66102A-08A

S E R V I C E N O T E

66102A DC Power Supply

The instrument will not communicate or will not complete self test.

Figure 1

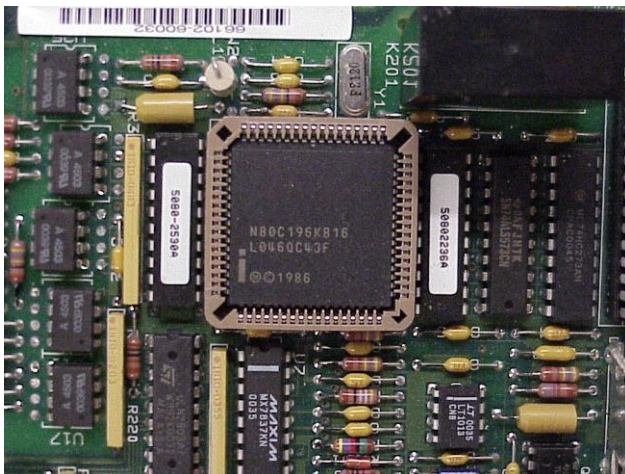
Figure 1 will help to identify the **68-PIN PLCC SOCKET location - P/N 1200-1274** (Circuit Reference “U001”)

Any Model having a serial number starting and ending with the serial numbers shown in the chart below should have the socket 68-PIN PLCC SOCKET - P/N 1200-1274 (Circuit Reference "U001") **REPLACED!**

Figure 2

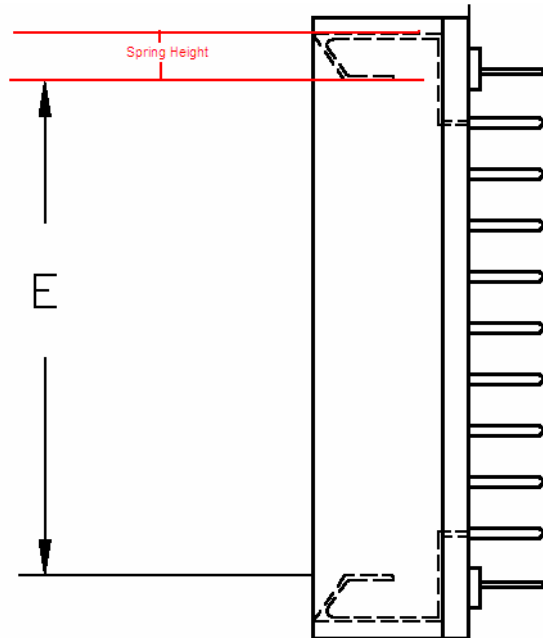
This figure should be used to identify **GOOD** sockets and a potential defective socket. The **16-Bit MCU 16 MHZ 68PLCC CMOS IC (P/N 1821-1479)** is **NOT** pictured.

The following information will help identify each socket type and manufacturer. The manufacturer's logo can be identified as shown. After the **16-Bit MCU 16 MHZ 68PLCC CMOS IC** has been removed there are also mold markings that can be easily viewed these markings should be used to identify a **Good or Defective socket**.

- Socket **"A"** is a sample of a GOOD AMP socket.
- Socket **"B"** is a sample of a GOOD Tyco/Augit socket.
- Socket **"C"** is a sample of a GOOD FCI socket.
- Socket **"D"** is a sample of a DEFECTIVE Tyco socket.

The sockets above labeled **"A", "B" or "C"** are good and should NOT be replaced.
The socket above labeled **"D"** is considered defective should be replaced.

Discipline B – Verification of Corrective Action “The socket shown in the pictures are for reference ONLY”

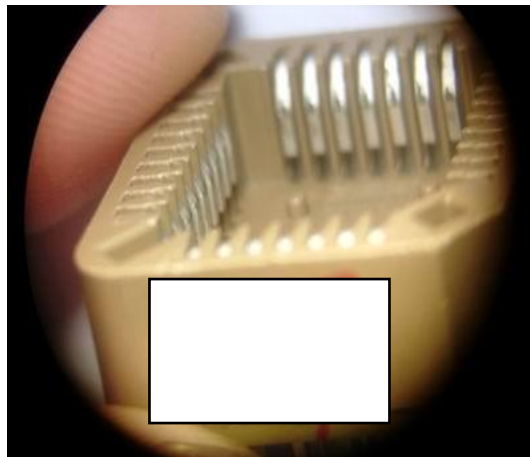
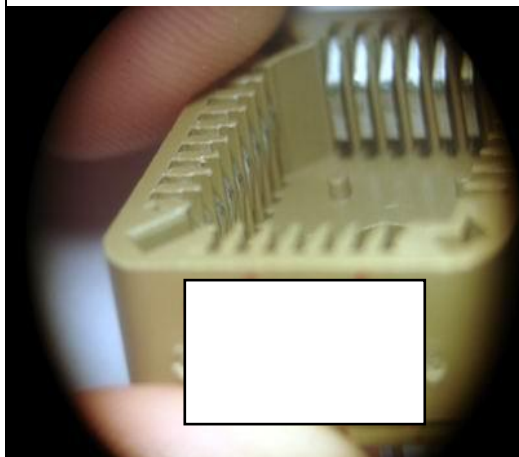
The condition of the recessed beams has been corrected by a design enhancement implemented in production. This design enhancement increased the spring height dimension by 0.04mm and decreased the spring height tolerance by 40%. The spring height dimension is shown in the drawing below.

This design enhancement is intended to position the contact beams closer to the middle of the socket and increase the normal force exerted on the contacts of the chips mated to the socket.

The effectiveness of this design enhancement was tested by comparing the mating and un-mating forces on the older and newer designs. The test results for sockets with the increased spring height (newer design) showed an increase in the mean mating force of 18.9% and an increase in the mean un-mating force of 23.4%. The increase in the un-mating force test results between the old design and the new design indicate that a greater normal force is being exerted on the test chip contacts by the socket contact beams. The two revisions of this contact beam design were visually examined after the mating and un-mating force testing. Photos of the two sockets are shown below. The photo on the left shows the older version socket prior to the enhanced contact beam design. The photo on the right shows a socket with the design enhancement. The contacts with the older design appear to be recessed farther into the housing after un-mating.

Material with this design enhancement will be labeled with a 2007 date code
